MONTGOMERY COUNTY HISTORIC PRESERVATION COMMISSION
STAFF REPORT

Address:	7305 Takoma Avenue, Takoma Park	Meeting Date:	6/14/2023
Resource:	Contributing Resource Takoma Park Historic District	Report Date:	6/7/2023
Applicant:	Richard Henrich	Public Notice:	5/31/2023
Review:	HAWP	Tax Credit:	N/A
Permit Number:	1028895	Staff:	John Liebertz
PROPOSAL:	Installation of solar panels

STAFF RECOMMENDATION

Figure 4: The proposed solar arrays and exterior conduit (red line) at 7305 Takoma Avenue.

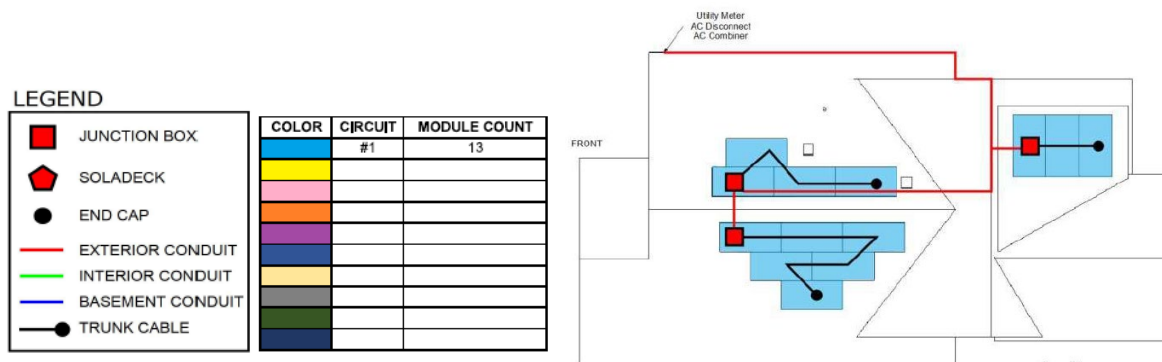
Staff recommends approval for the placement of exterior conduit wire with a condition. *Policy Guidance #20-01: Solar Technology (2021)* states that all conduits for connections to electrical meters should be placed on the inside of the building or on a secondary elevation. The proposal includes conduit wire running along the ridge of the rear addition to the west elevation (Figure 4). This conduit should be placed within the building to the greatest extent possible or tucked under the overhanging eave on the west elevation to reduce visibility from the public rights-of-way. Staff requests the applicant submit justification for the exterior conduit and a drawing/annotated photograph that illustrates the location of the exterior conduit (if required).

Staff recommends approval for the placement of the all exterior disconnects and combiners for the solar array with a condition. While this equipment is placed within view of the public right-of-way on the west elevation (towards the front porch), it is adjacent to an existing utility meter and would not further diminish the integrity of the resource. The applicant should submit specification sheets for all exterior hardware and an annotated photograph that illustrates its approximate location on the elevation.

1. The applicant shall submit justification for the exterior conduit (instead of an interior placement) and an elevation/annotated photograph that illustrates the location of the exterior conduit if required
2. The applicant shall submit specification sheets for all exterior inverters, combiners, etc. and an annotated photograph that illustrates their approximate location adjacent to the existing utility meters.
